SHEET TITLE:
BLOCK GRADING PLAN (SOUTH WEST)

CLIENT:
**FICKLING AND CO.
MACON, GA**

PROJECT:
**LULLWATER AT FORT
CLARKE BLVD**

SHEET TITLE: **BLOCK GRADING PLAN (CENTRAL EAST)**

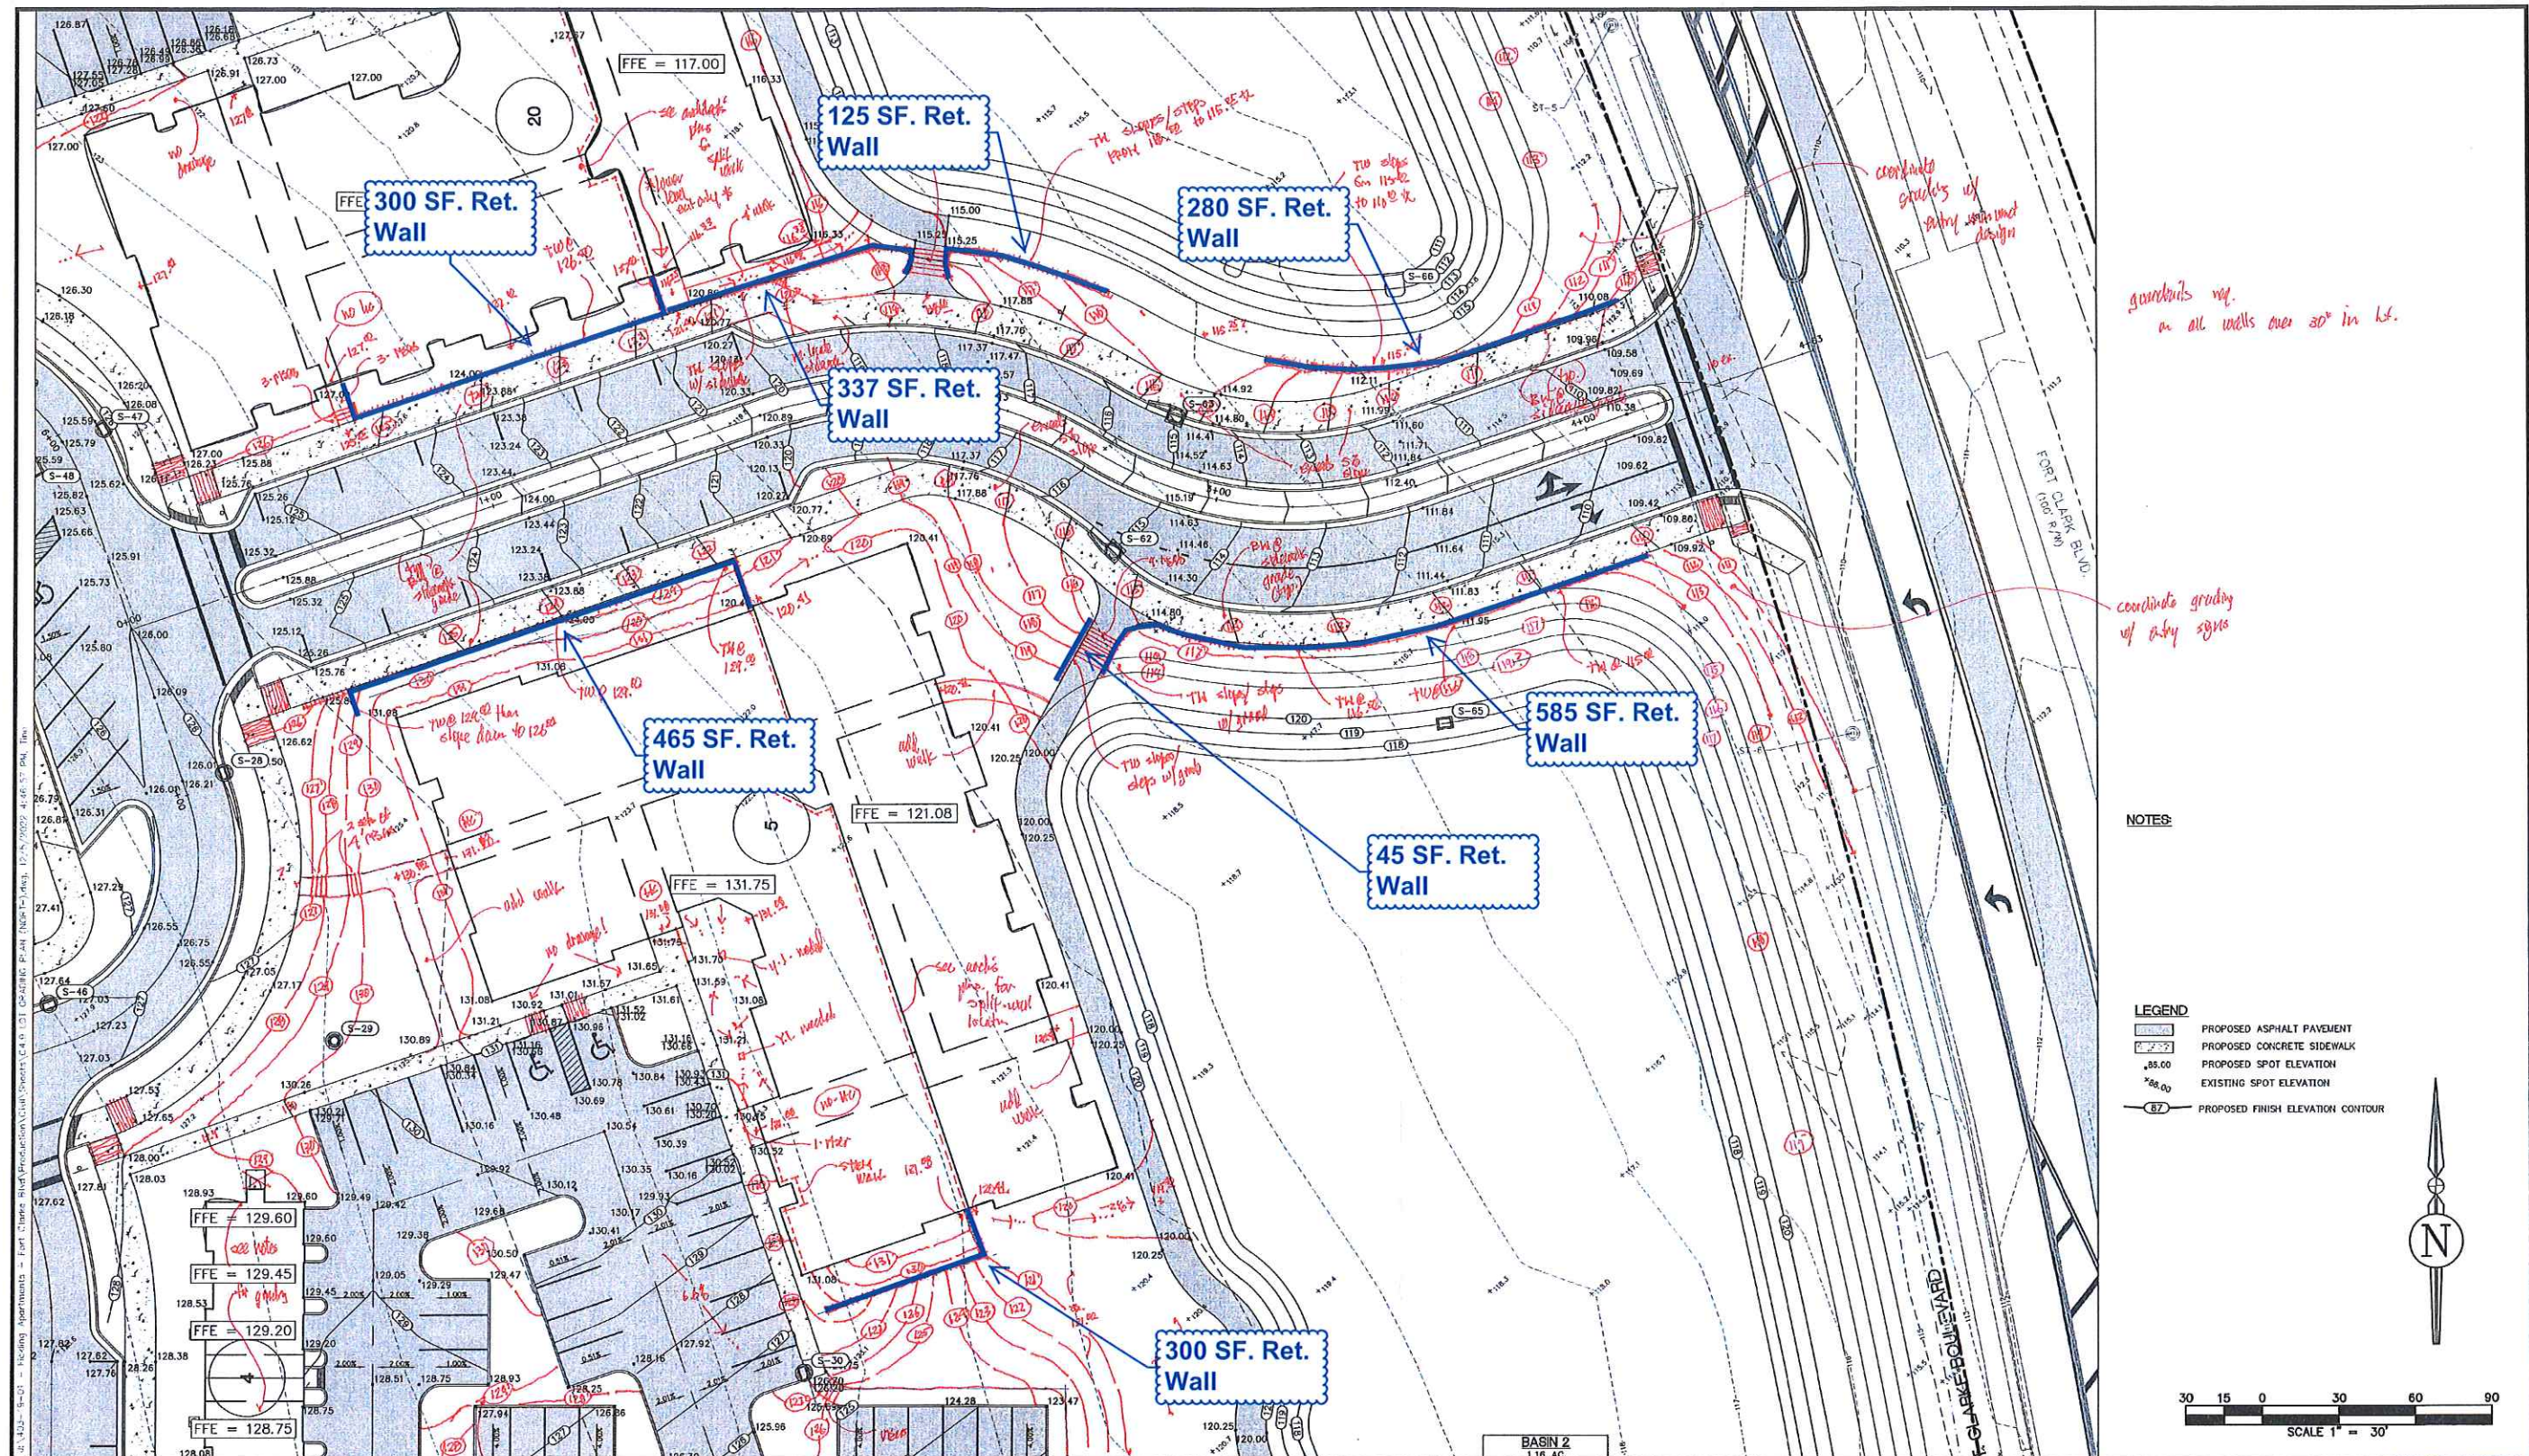
guardrails req.
on all walls over 30' in ht.

coordinate grading
w/ city signs

Ret. Walls may be required along buffer. Not determined at this time.
